## THE BOND (fka The District) JSP18-10

Public hearing at the request of DTN Management/Tricap Holdings for JSP 18-10 for recommendation to the City Council for approval or denial of Preliminary Site Plan, Phasing Plan, Woodlands Permit, and Storm Water Management Plan. The Subject Property Is Currently Zoned TC-1 (Town Center One) and is approximately 7.74 acres. It is located west side of Flint Street in the south west corner of Grand River Avenue and Novi Road in Section 22. The applicant is proposing a mixed use development with two four-story multi-family residential buildings with a total of 253 apartments and a single-story commercial building (5,578 SF). The site improvements include a two level parking structure, surface parking, site amenities and related landscape improvements. The applicant is proposing a phased construction in three phases. The applicant is proposing to dedicate six parking spaces in the Commercial parking lot as a benefit to the Novi Public Cemetery visitors.

## PLANNING REVIEW

**Review Date:** June 15, 2018  
**Review Type:** Revised Preliminary Site Plan  
**Project Name:** **18-10 BOND FKA THE DISTRICT**  
**Plan Date:** June 11, 2018  
**Prepar

**OVERALL SITE PLAN**

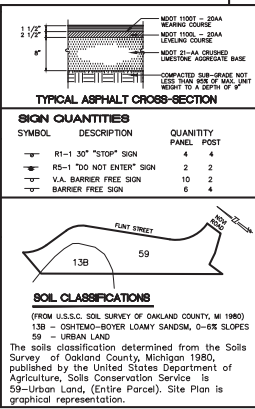
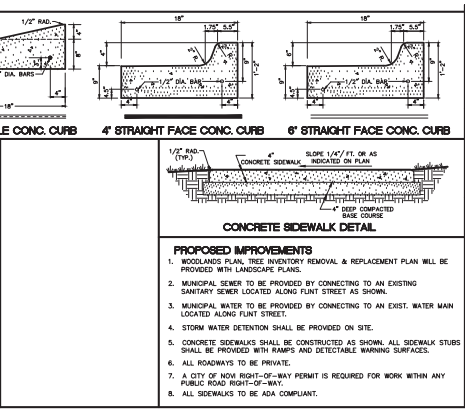
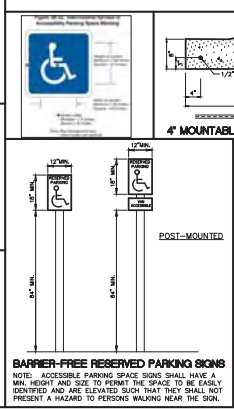
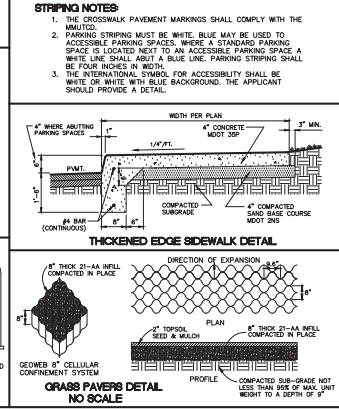
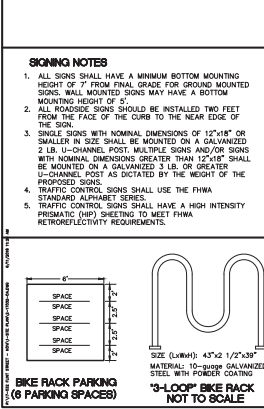
- a. Phasing (Pg 2 of 19) – Building and parking counts will be added to the Phasing Plan
    - b. Building Height (Pg 3 of 19) – Maximum building height will be added to the Site Plan Data on sheet 2 of the Site Plan

**Figure 1.** City of Novi Regulated Wetland & Woodland Map (approximate property boundary shown in red). Regulated Woodland areas are shown in green and regulated Wetland areas are shown in blue.

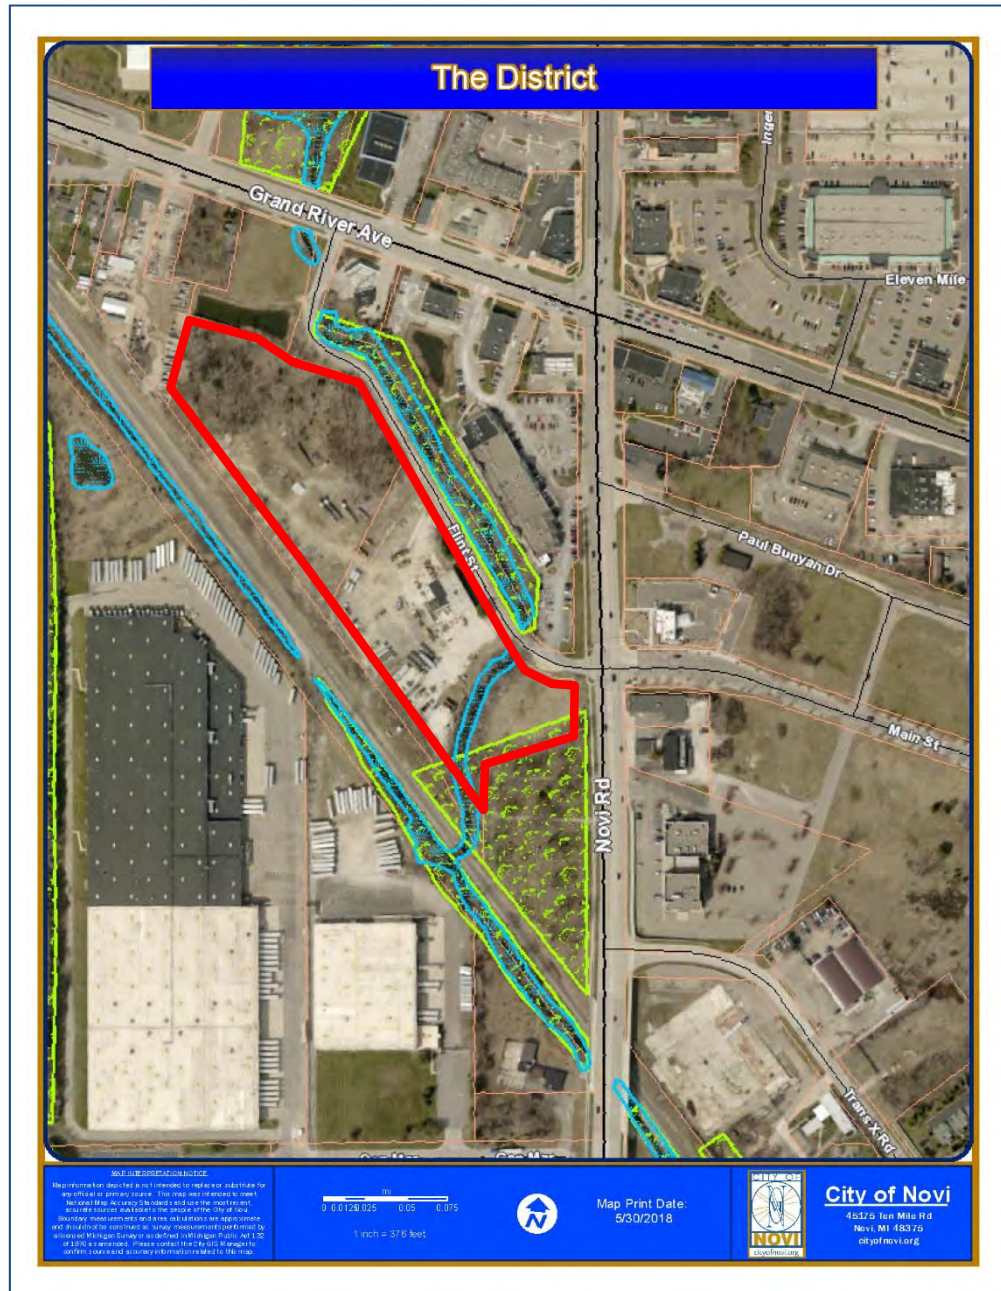
ECT completed an on-site woodland evaluation on November 7, 2017. The site appears to contain an area indicated as City of Novi Regulated Woodlands (see Figure 1). This area is located in the southeast section of the site, along the Walled Lake Branch of the Middle Rouge River. Areas mapped as Regulated Woodlands are also located adjacent to the site, across Flint Street.
